SERVICE BULLETIN

No. 199A

Piper Aircraft Corporation

SUBJECT: Reinforcement of Stabilator Trim Tab Horns

Sketch "A"

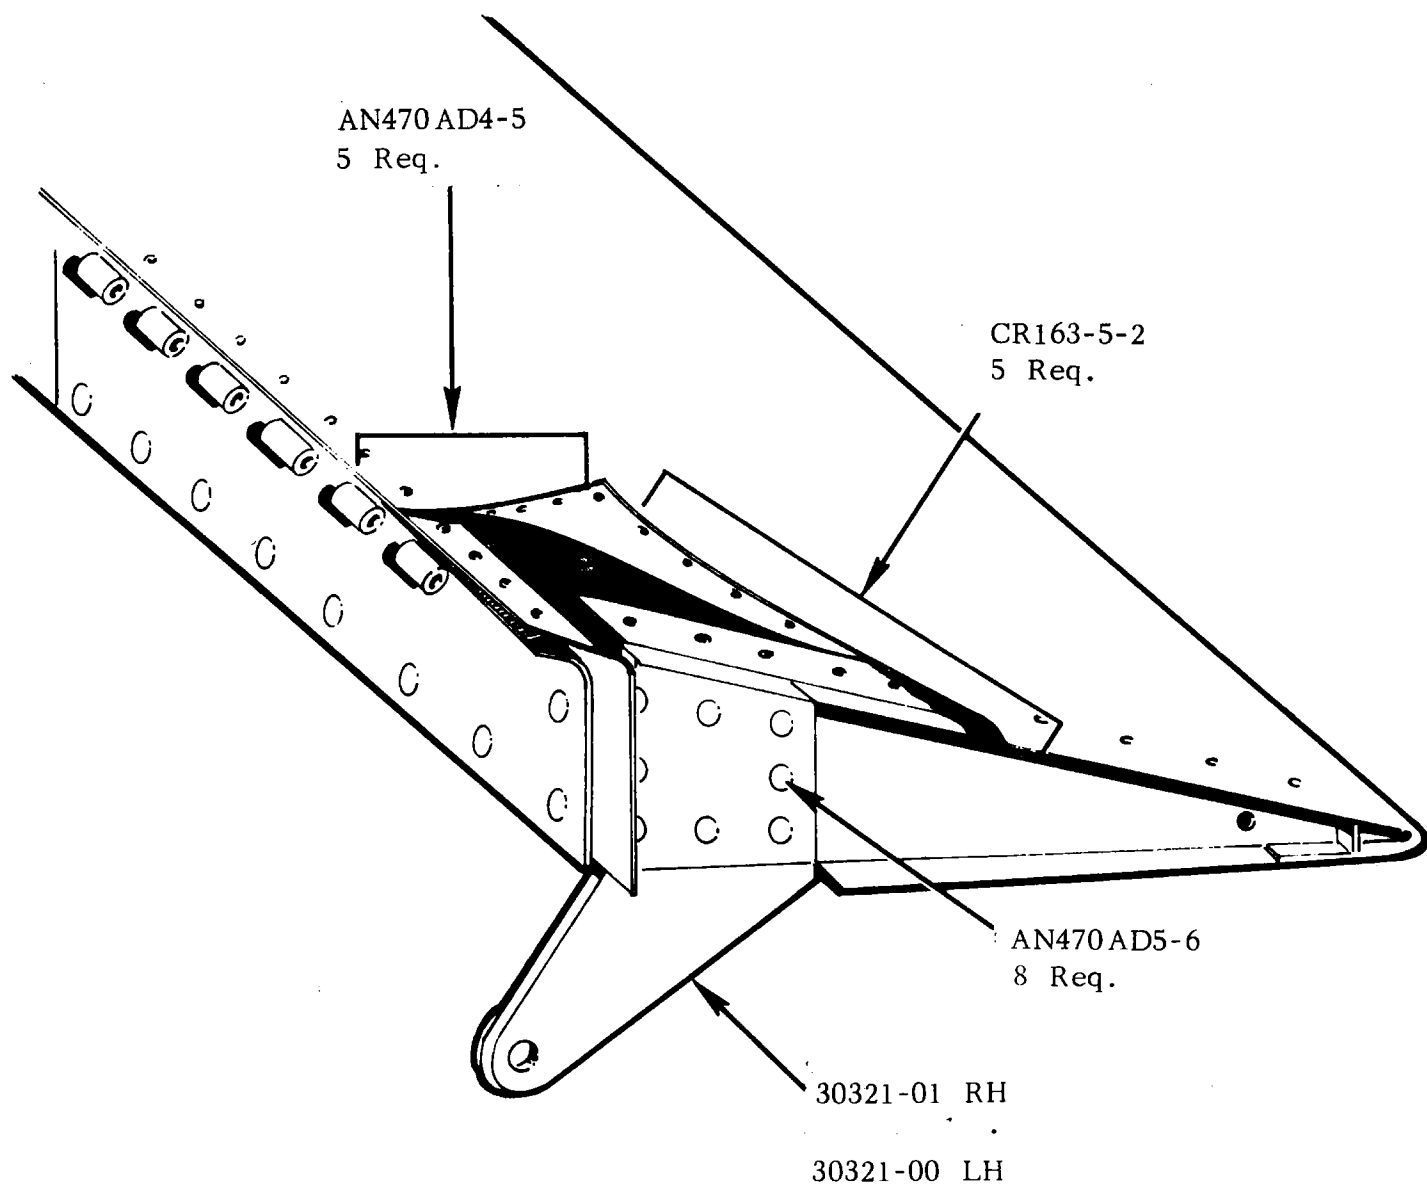
It is requested that, prior to the installation of this kit, the stabilator trim tab horns be inspected visually for indication of cracks. If the horn, or horns, is found to be cracked, it must be replaced before modification. Please refer to attached Sketches "A" and "B" for detailed instructions. Note locations where the use of explosive rivets is approved.

REPLACEMENT OF TAB HORN

Sketch "B"

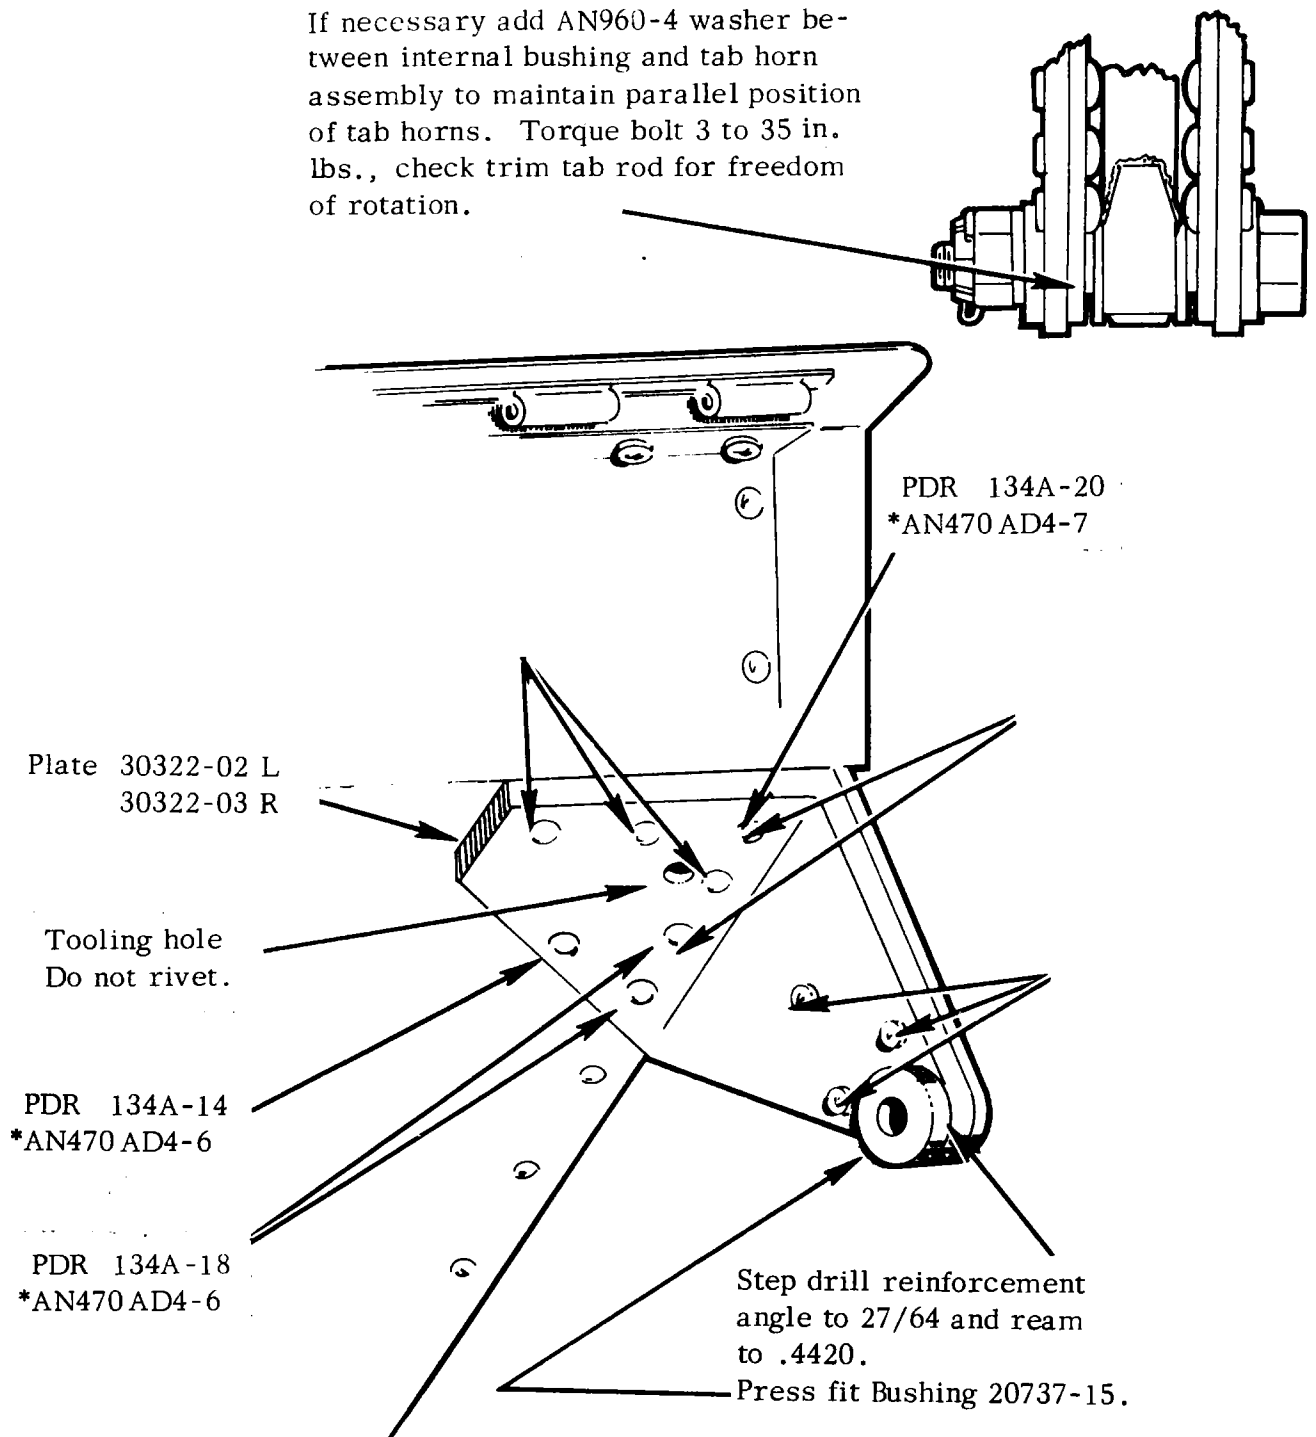
REINFORCEMENT OF TAB HORN

If necessary add AN960-4 washer between internal bushing and tab horn assembly to maintain parallel position of tab horns. Torque bolt 3 to 35 in. lbs., check trim tab rod for freedom of rotation.
